Document #: 8ZDGF-1595

Nidec Components Corporation  
Sensor Division

### Product process change notification for liquid leak sensor WL10 series

##### 【Production process of Mask】

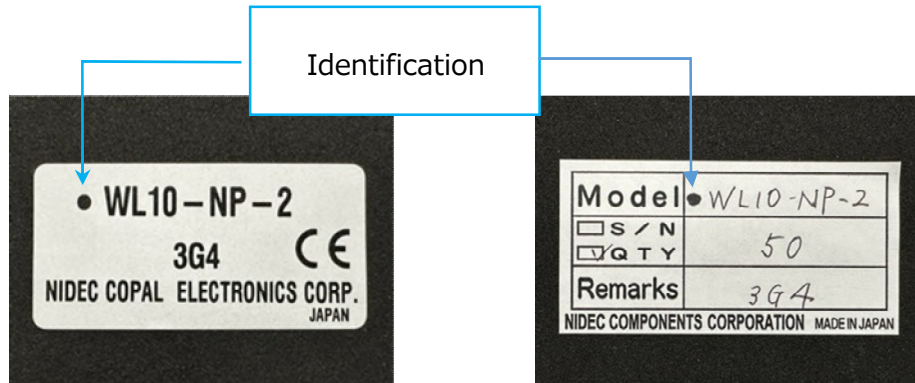
The film of the production tooling used to cut parts of the darkening mask will be changed from non-RoHS compliant to RoHS compliant.

- i . Production of material sheet for mask
- ii . Placing the sheet on the film in order to avoid the cut sheet being spread over  
Changing the type of film from non-conforming to RoHS conforming
- iii . Cutting
- iv . Picking up mask from the sheet

The film used as tooling turned out to be RoHS non-conforming. In order to be in compliance with RoHS directive, NCCC decides to change the film to RoHS conforming. Since the film is not a part of product and is used just as tooling, changing the type of film doesn't affect the quality and performance of WL-10 by any means.
